UNITED STATES DEPARTMENT OF COMMERCE
National Oceanic and Atmospheric Administration
NATIONAL MARINE FISHERIES SERVICE
West Coast Region
7600 Sand Point Way NE, Bldg. 1
Seattle, Washington 98115

Re: Sacramento River Temperature Management Plan

Reclamation's June 27, 2016, Sacramento River Temperature Management Plan

Figure 3. Lake Shasta End of April Storage Potential for Meeting Compliance Point Target.

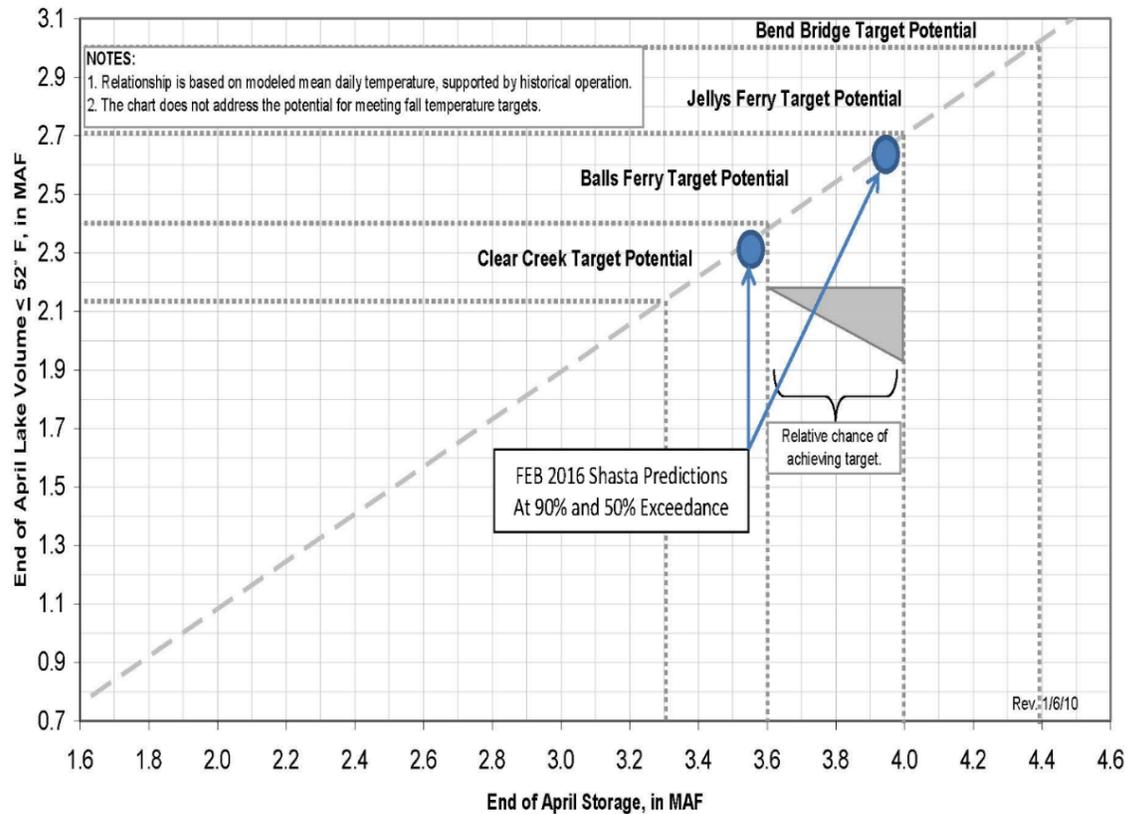
According to Reclamation’s 90% hydrological exceedance 2016 February Forecast (Table 2), the forecasted EOA storage for Shasta Reservoir is approximately 3.45 MAF. According to Reclamation’s potential for meeting a Sacramento River water temperature compliance point target² of 56°F DAT at Jellys Ferry, there needs to be an EOA storage of at least 4.0 MAF (Figure 3). According to the 1996 to 2015 historical record (Table 1), an EOA storage of at least 4.2 MAF was necessary in order to meet the Jelly’s Ferry TCP in 4 out of 7 years. Therefore, based on the currently proposed monthly average releases from Keswick Dam, Reclamation will not be able to meet a TCP of not in excess of 56°F DAT at JLF.

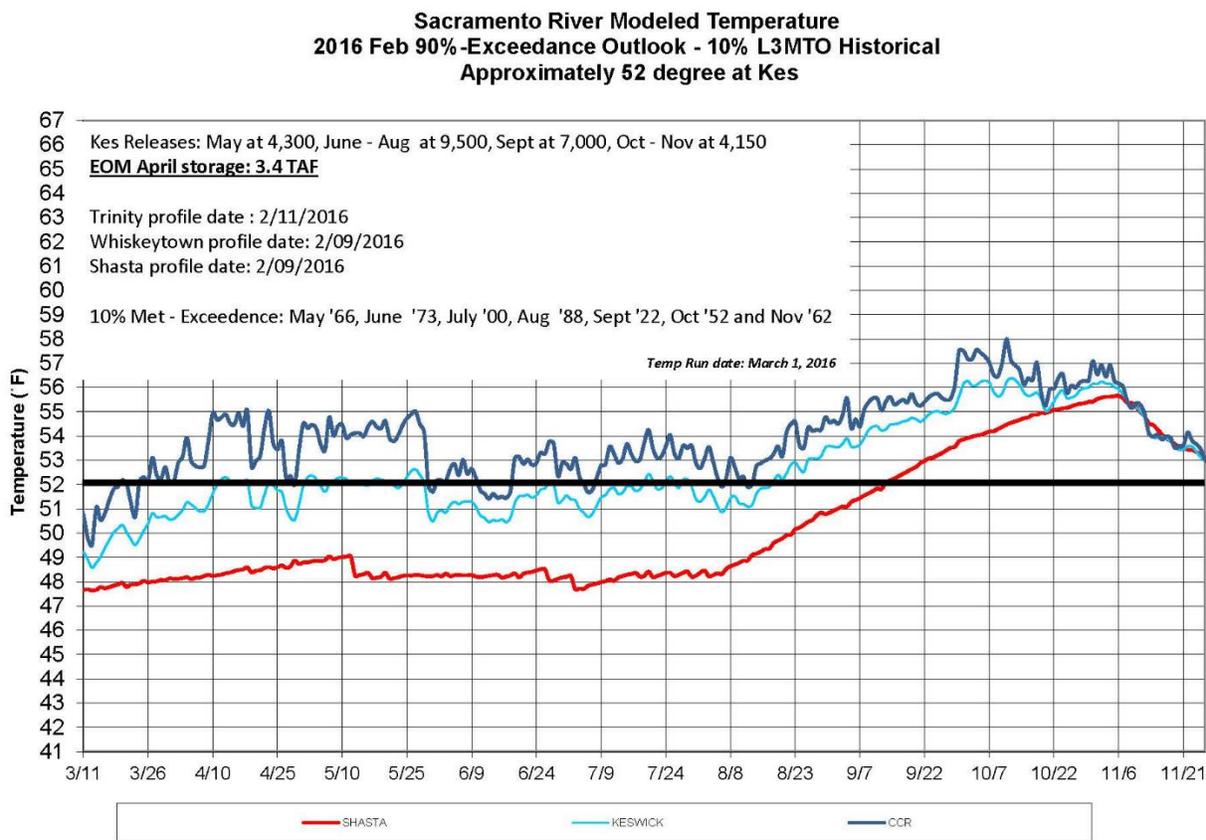
On March 15, 2016, NMFS received from Reclamation a preliminary set of Sacramento temperature model results targeting water temperatures at Keswick Dam release point and CCR based on the February 1, 2016, hydrologic conditions and forecasted river inflow. According to the 90% exceedance hydrology, Reclamation’s proposed Keswick Dam monthly average releases for May through November (Table 2), and targeting 52°F DAT at the Keswick release point³ (KWK), Reclamation would only be able to meet 52°F DAT at KWK until a couple of days before August 23rd (Figure 4). After that date, the cold water pool in Shasta Reservoir would be depleted and/or inaccessible and the DAT at KWK would increase to more than 56°F for the rest of the temperature management season.

NMFS-SWFSC modeled the same operational scenario using their River Assessment for Forecasting Temperatures (RAFT) model. Their results were similar to Reclamation’s temperature model results in that Reclamation would only be able to meet a 52°F DAT at KWK until then end of August (Figure 5). Again, after that, the cold water pool in Shasta Reservoir

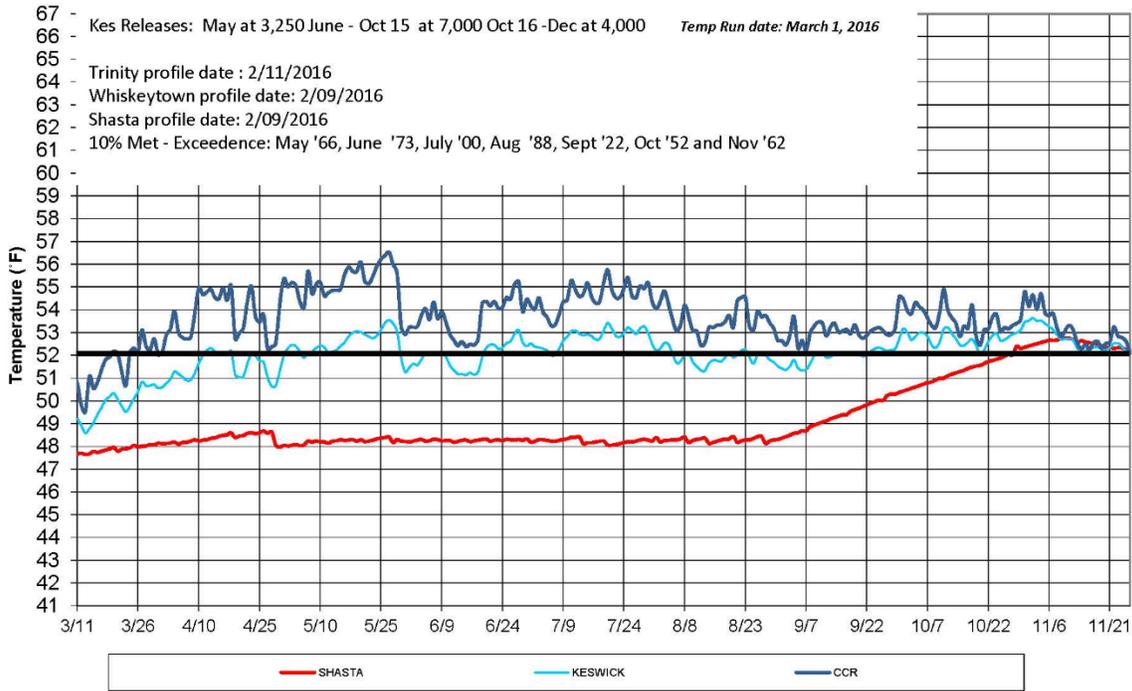
Reclamation ran their Sacramento River Water Quality Model based on the NMFS scenario for Keswick Dam release schedule (Figure 7). The results show that 52°F DAT target at KWK can be achieved throughout the temperature management season with some occasional exceedances.

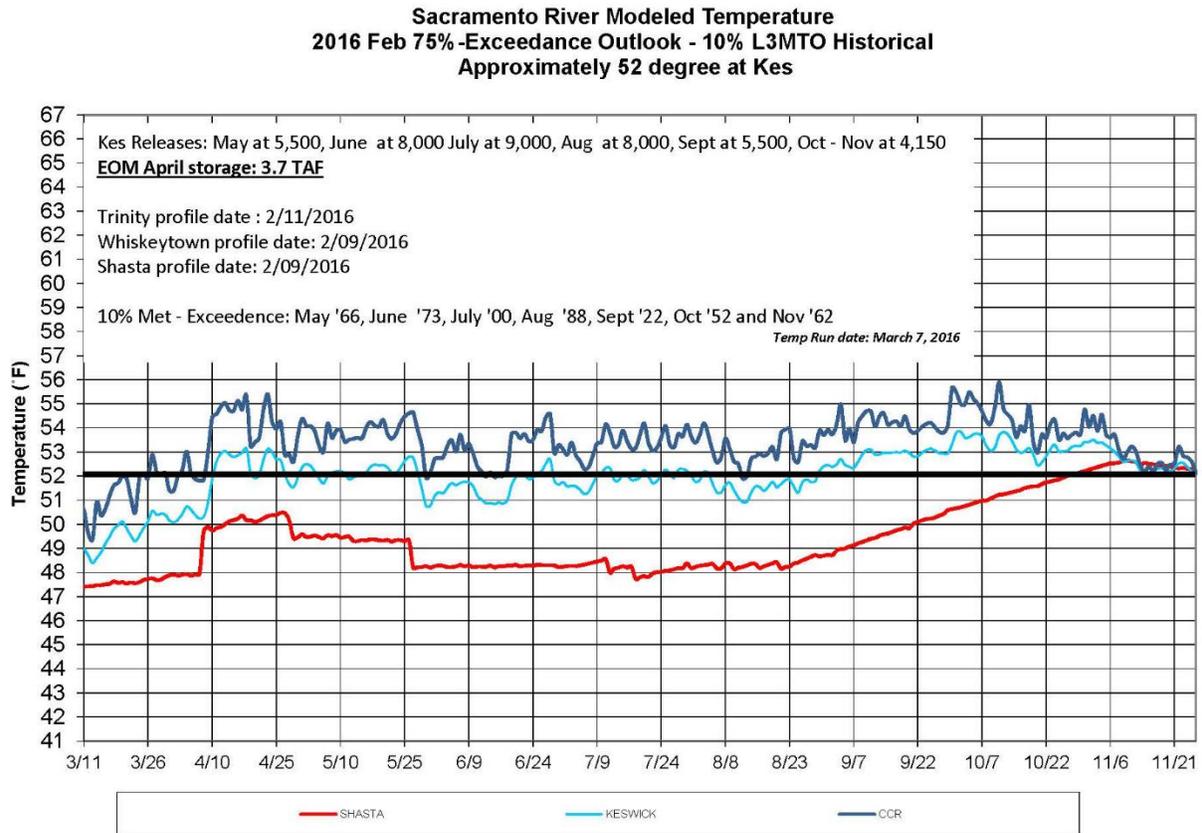
Reclamation also ran their Sacramento River Water Quality Model using the 75% exceedance outlook and their proposed Keswick Dam monthly average release schedule. Similar to the 90% hydrological exceedance, Reclamation would only be able to meet 52°F DAT at KWK until about the end of August (Figure 9). After that, KWK DAT would rise to a peak of about 54°F through the end September and October.

Figure 7. Average Degrees Above 56°F DAT at Compliance Point (1997-2015).

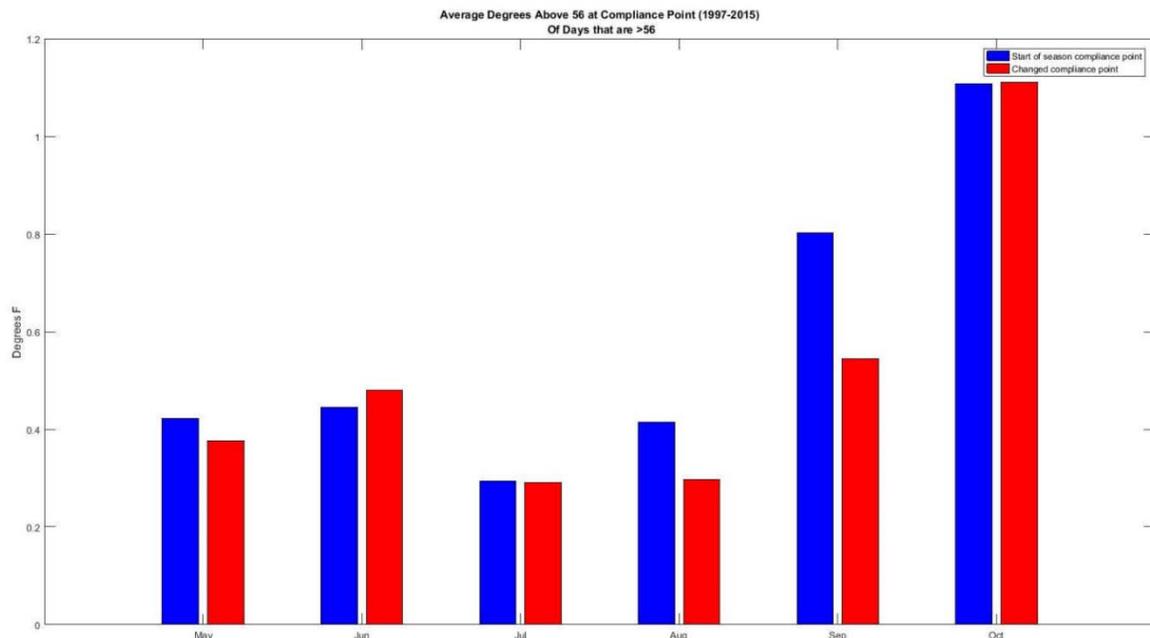
This leaves the uncertainty with the Reclamation model scenarios. These analyses only use the discharge temperature and flow at Keswick predicted by the SRWQM, but to get those values correct for the entire season for all of the scenarios, Reclamation needs to get all of the environmental input variables accurate: the reservoir inflows, weather, operations (gate changes, etc.), reservoir dynamics, over a 6-month period. Historically, Reclamation has overestimated their ability to meet the temperature compliance points (Figure 6). Over the past 10 years, the, 56°F DAT at a temperature compliance point specified at the beginning of the season was exceeded ~33% of the time (11% in May, 20% in June, 29% in July, 41% in Aug, 54% in Sept,

and 44% in Oct). The compliance points can change over the course of a season which does minimize the frequency and magnitude of exceeding the 56°F DAT, but the bottom line is that Reclamation exceeds the 56°F DAT at any temperature compliance point a significant amount of the time, and often by a significant temperature differential (Figure 7). The higher that differential, the higher the likelihood of egg mortality, especially when temperatures exceed the T_{crit} values.

Figure 8. 55°F 7DADM at Clear Creek (CCR) in relation to the flow and temperature at Keswick by month. Dotted lines are 95% contour intervals.

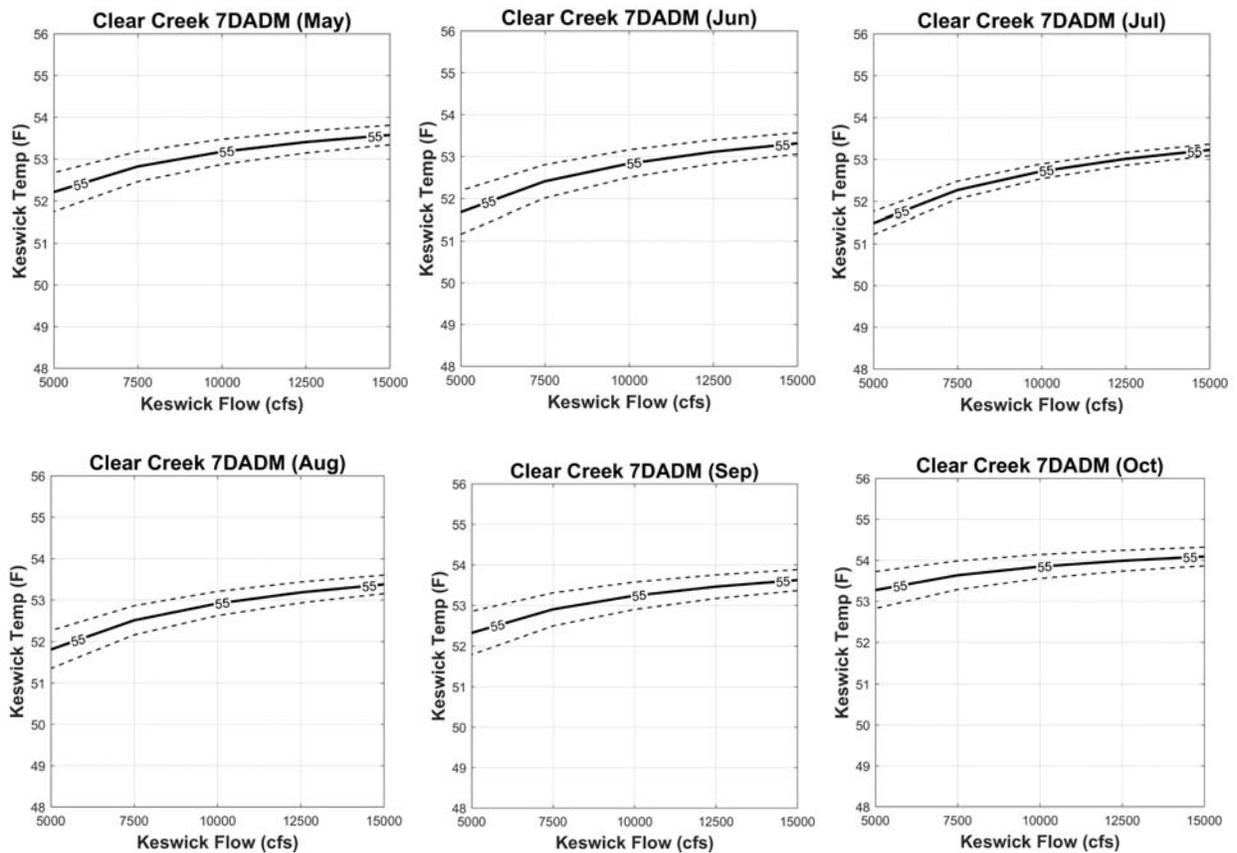
Based on RAFT runs using a constant flow and temperature at Keswick, under average meteorological conditions, the NMFS-SWFSC generated contour plots of the 55°F 7DADM at CCR in relation to the flow and temperature at Keswick for each month (*i.e.*, the release temperatures at Keswick that would be needed to meet 7DADM at CCR for each month) (Figure 8). In general, there is a small difference in general between 5,000 and 7,500 cfs, but above that, small increases in flow (*e.g.*, 500 cfs) do not make much of a difference in the Keswick release temperature.

Figure 9. 55°F 7DADM at Clear Creek (CCR) in relation to a 56°F DAT downstream by month

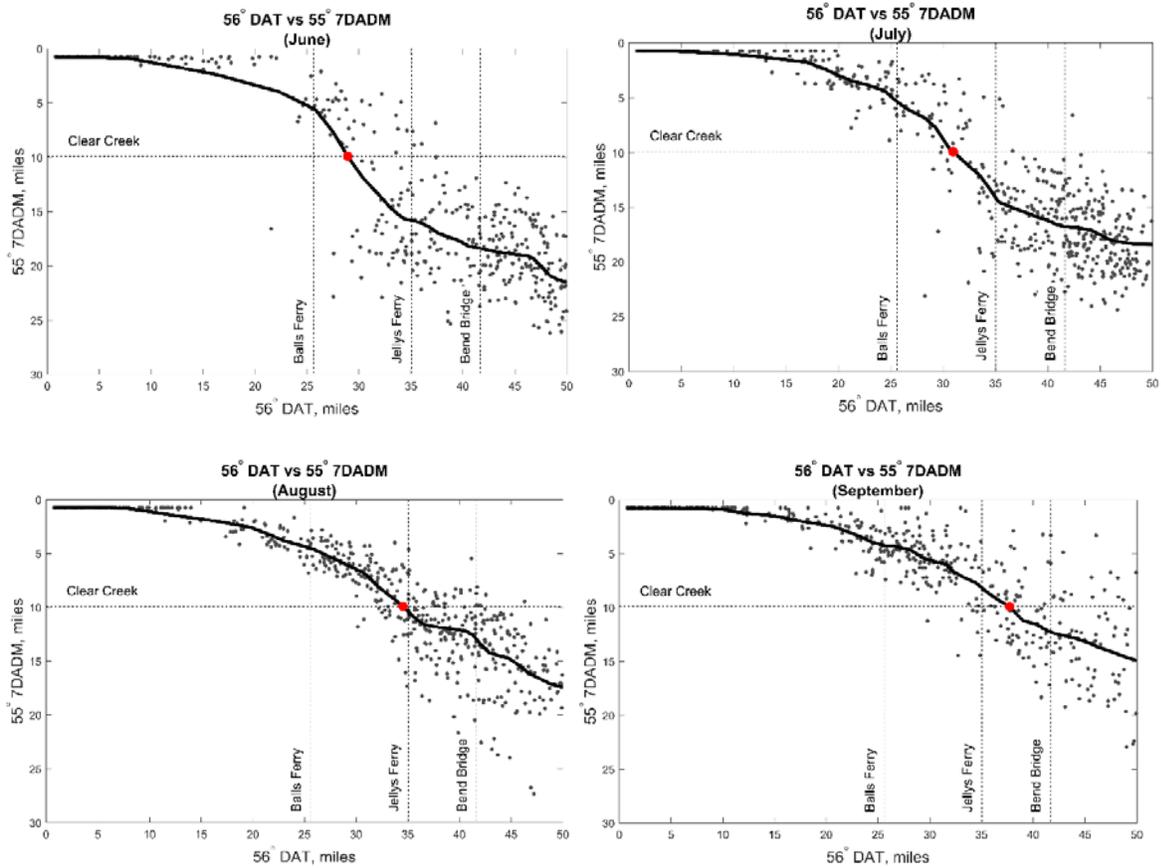
The NMFS-SWFSC also ran an analysis relating 55°F 7DADM at CCR to a 56°F DAT downstream, divided up by month, based on historical data (Figure 9). Each point represents a day from 1997-2015. A curve was plotted through these points that calculated where the 56°F DAT would be the same as the 55°F 7DADM at CCR. Within an individual month there is lots of scatter and this is mainly related to meteorology. However, between months, the location of 56°F DAT equal to 55°F 7DADM at CCR moves downstream as the summer progresses. It ranges from 28 miles below Keswick in June to almost 38 miles in September.

Figure 10. 56°F DAT at Balls Ferry in relation to a 7DADM downstream by month.

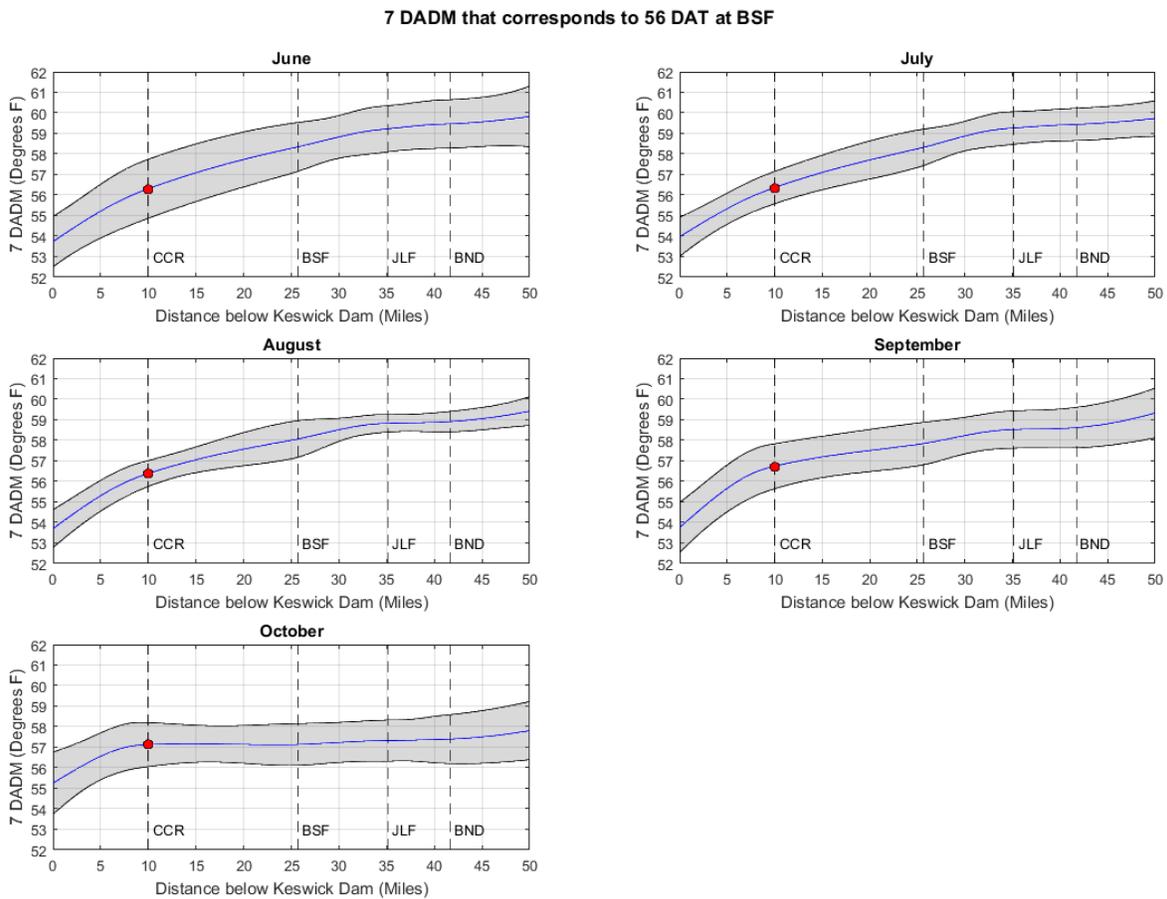
In addition they ran an inverse of the above analysis, relating 56°F DAT at Balls Ferry (BSF) to 7DADM downstream using data from 1997-2015 (Figure 10). The figure shows the 7 DADM for those days, at all locations. The mean is shown with the blue line, +/- 2 standard deviations is shaded grey, and the mean at CCR is shown with the red dot. Figure 11 shows just the 7 DADM at CCR on days when the DAT is 56°F at BSF. It is plotted as a histogram to see the distribution of the data.

Figure 12. May 1, 2016 Shasta Reservoir Isothermobath

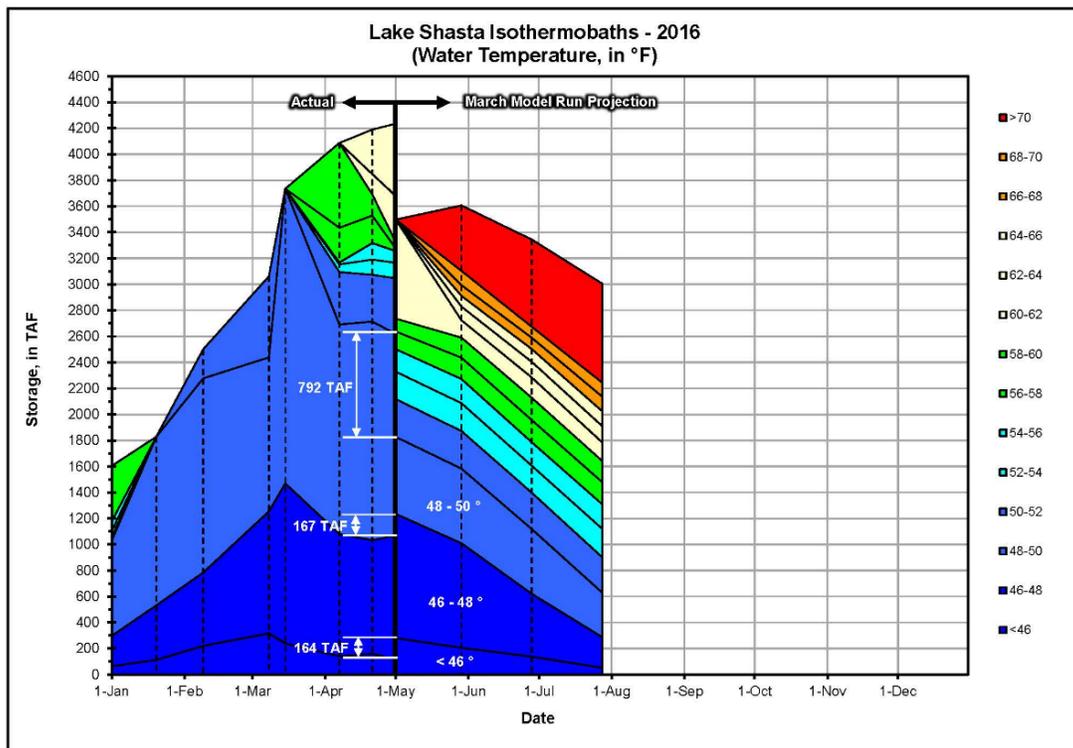
Based on the latest Shasta Reservoir temperature profile, Reclamation shared that there was 167 thousand acre-feet (TAF) less cold water (<48°F) at the beginning of May than there was according to the March forecast (Figure 12). Due to the decrease in cold water pool, Reclamation determined that targeting 52°F DAT out of Keswick reservoir was not achievable throughout the Sacramento River winter-run Chinook salmon spawning and egg incubation temperature management season (*i.e.*, approximately May 8 – October 15). Using the same Keswick flow releases proposed in March, Reclamation instead ran the April Sacramento River temperature model for the 90% and 50% exceedance hydrology (based on April 1, 2016, hydrologic conditions and forecasted river inflow) targeting a Keswick release DAT of 52.5°F (Figures 13 and 14).

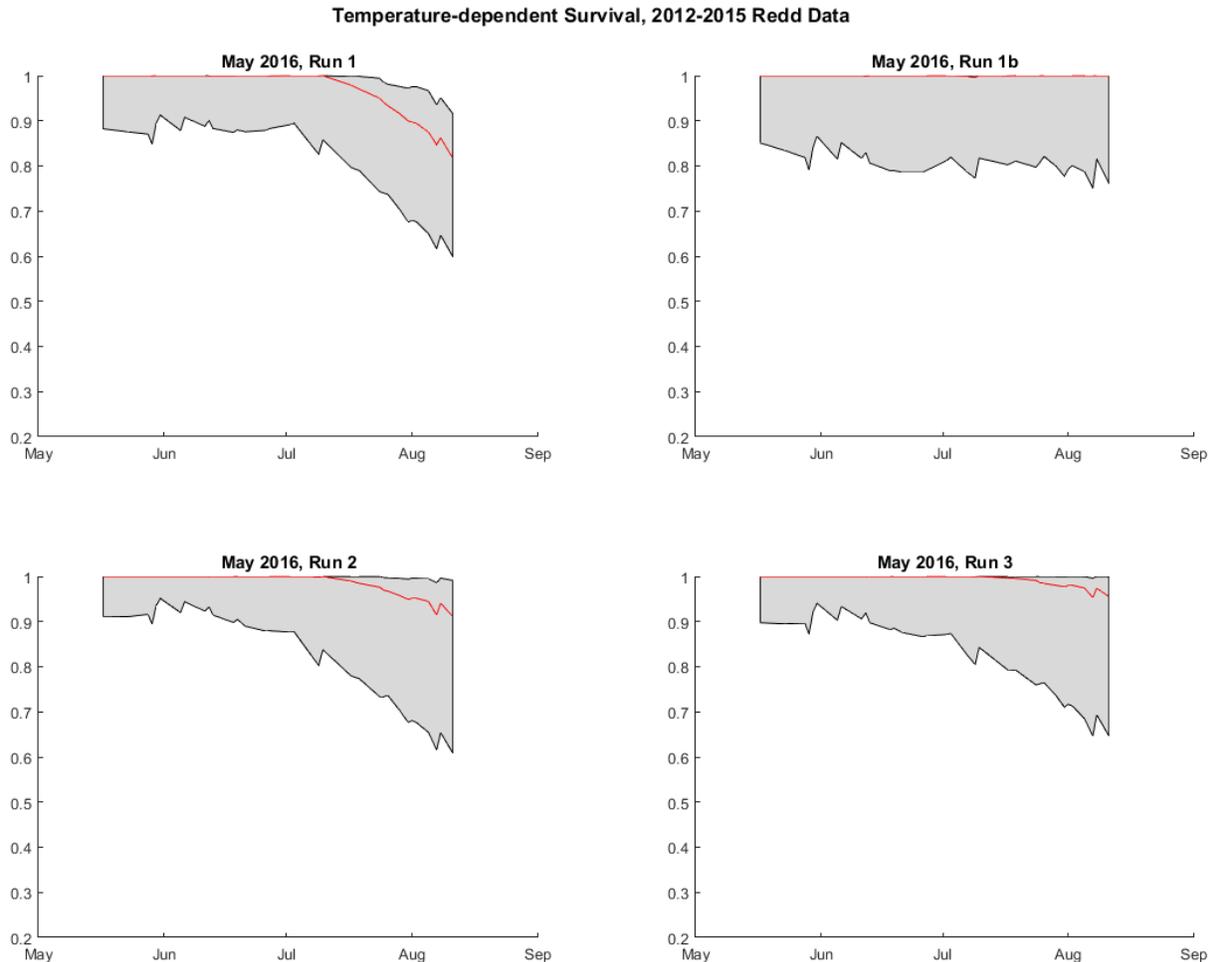
Figure 19 shows the temperature-dependent survival histogram and annual temperature-dependent mortality model results from each of the scenarios, with scenario 1b (*i.e.*, Keswick release flows for June through September of 8,500 cfs) having the least amount of mortality with a mean 5.2% (Table 5). Run 1b also pushed out the full side gate operations to the latest date of September 16.
